Development Review Committee

Staff Report

Case No: 14Devplan1154
Request: Waivers to allow the proposed stadium lighting to exceed the maximum mounting height; to allow the light trespass to exceed 0.5 foot-candles at property line; and to not provide full shielding.
Project Name: DeSales Athletic Field Stadium Lighting
Location: 425 West Kenwood Drive
Owner: Roman Catholic Bishop of Louisville
Applicant: St. Francis DeSales High School
Representative: Sabak, Wilson & Lingo, Inc.
Jurisdiction: Louisville Metro
Council District: 21 – Dan Johnson
Case Manager: Sherie' Long, Landscape Architect

Spillage at Property Line Foot-candle Lighting Plan

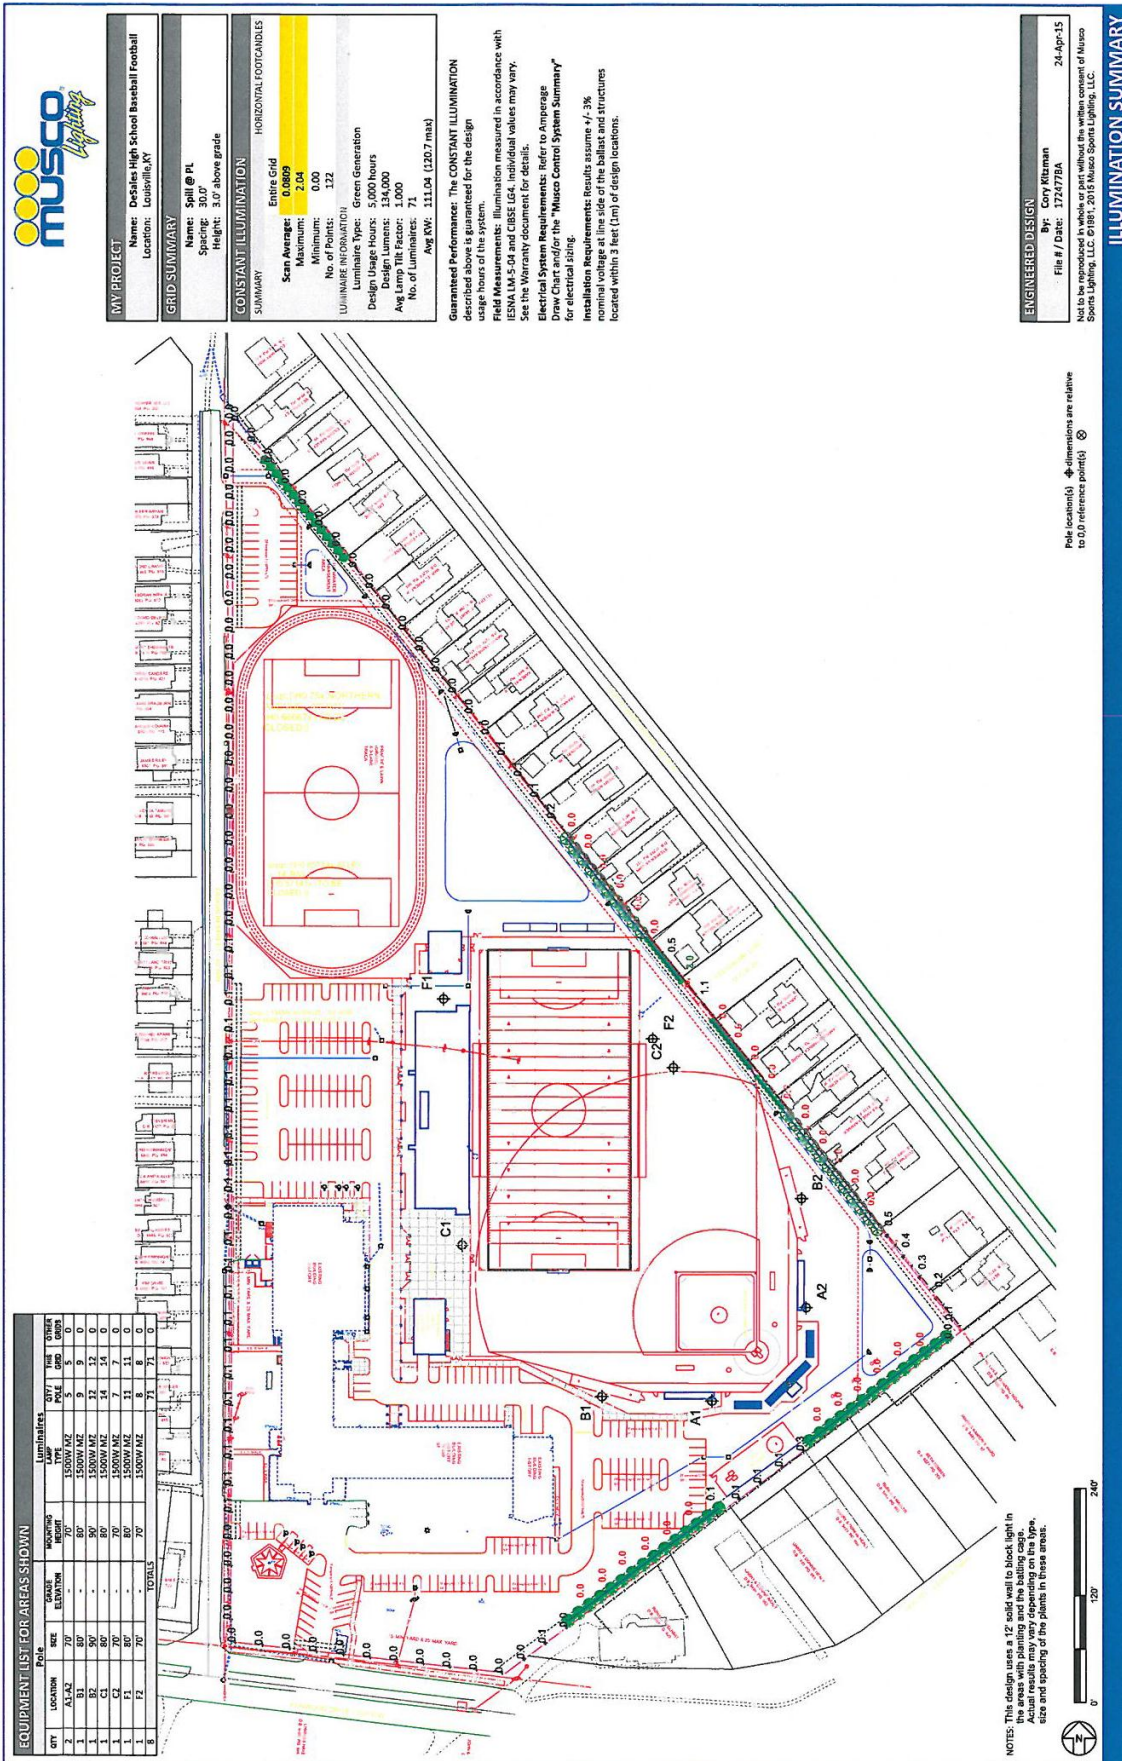
The maximum foot-candles at the property line shall be no greater than one-half (0.50) of a foot-candle. However, along the northeast perimeter this foot-candle requirement is not being met. The foot-candles along these perimeters exceed the maximum range by 0.6 to 1.5. The most sufficient trespass or spillage of light occurs along portions of the perimeter which does not have any additional planting or screening proposed to reduce or mitigate this non-compliance.

Attachment 6: Spillage/Trespass Exhibits

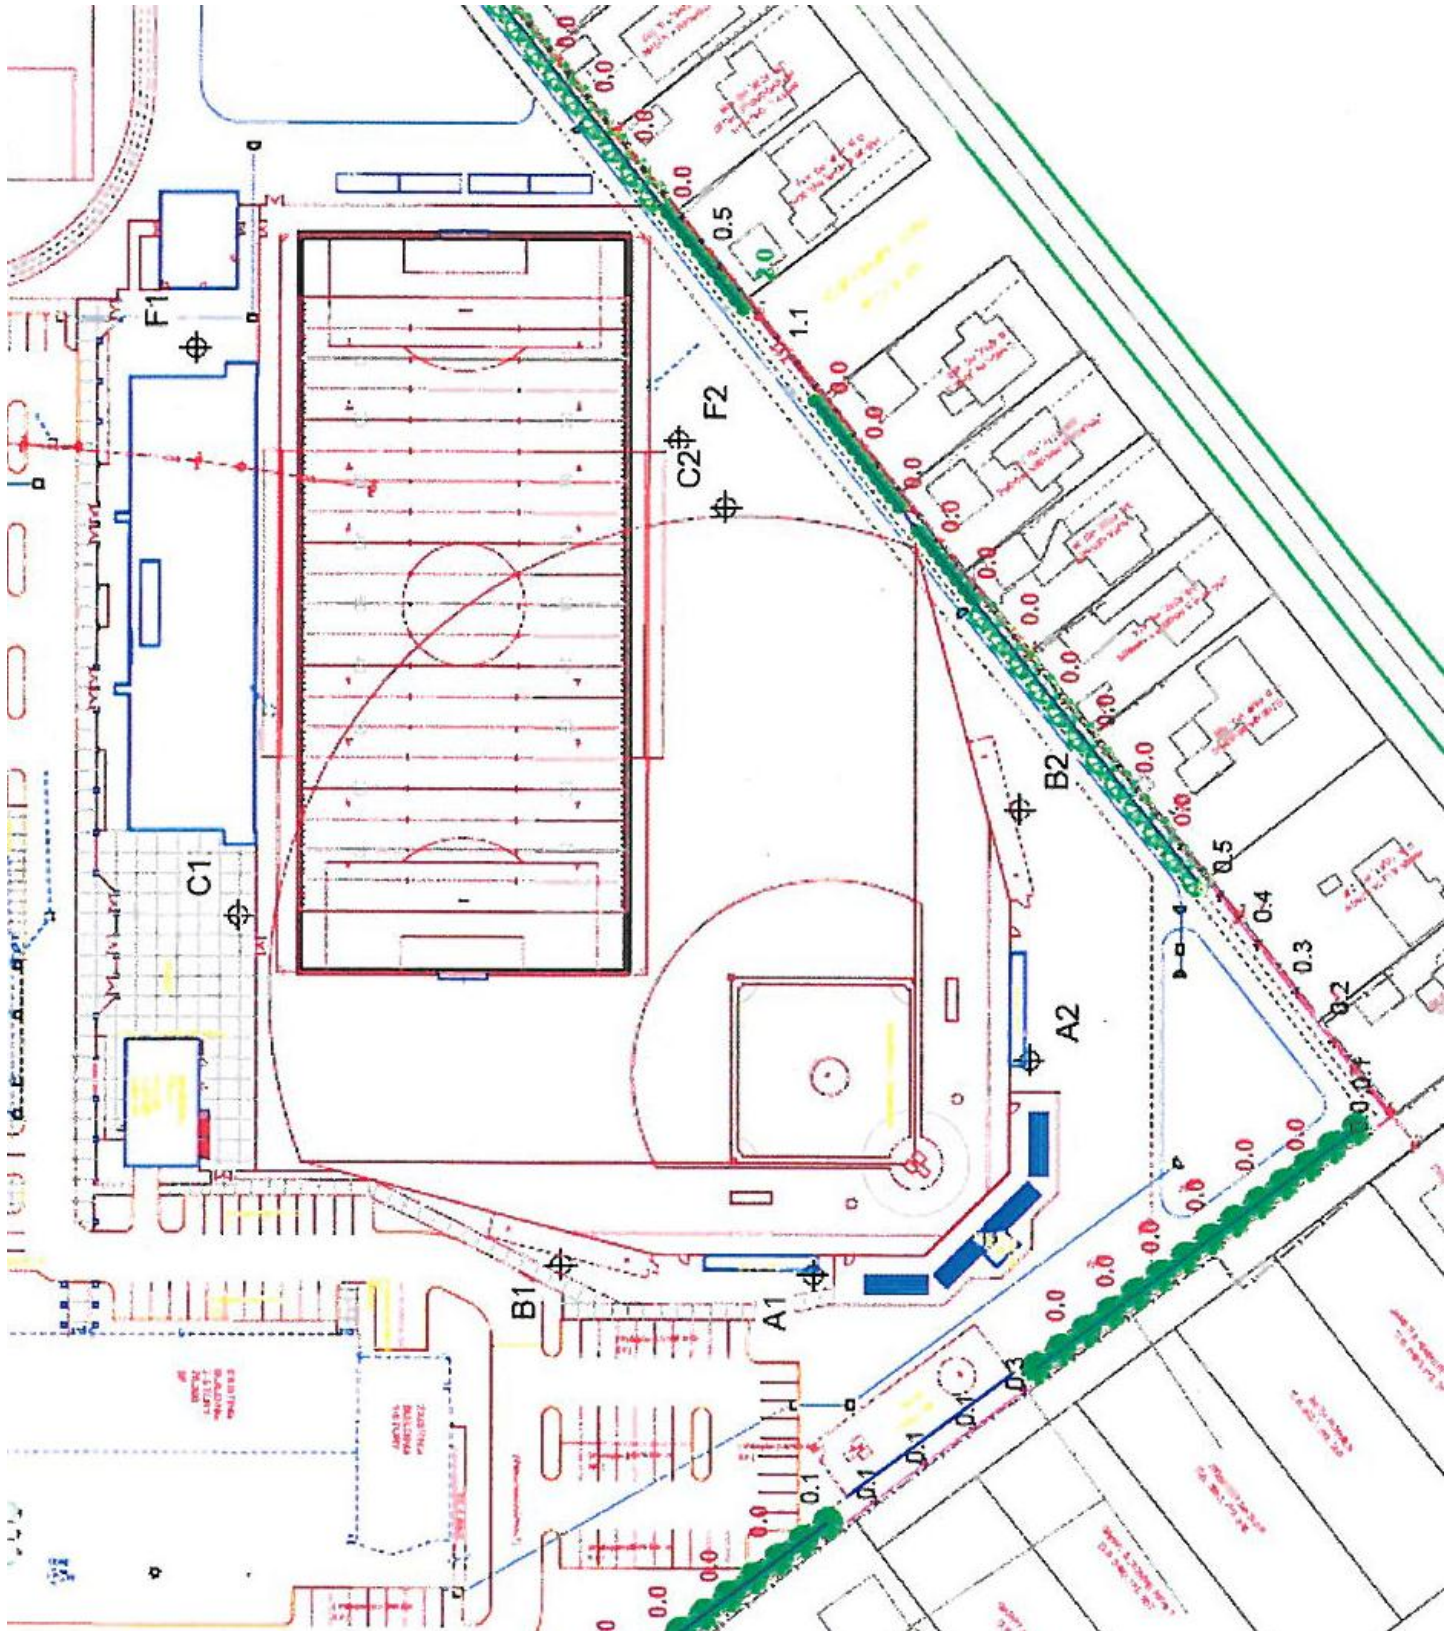
The applicant is requesting to be allowed to exceed the 20 foot mounting height for all eight (8) proposed fixtures by an additional 50 to 70 foot. The applicant is varying the height of the fixtures to reduce the impact of the proposed lighting on the adjacent residential properties; however there is some trespass light or spillage of the light onto the adjacent residential properties. Therefore, a waiver is also being requested to allow the trespass or spillage of the light onto the adjacent residential properties to exceed the maximum.
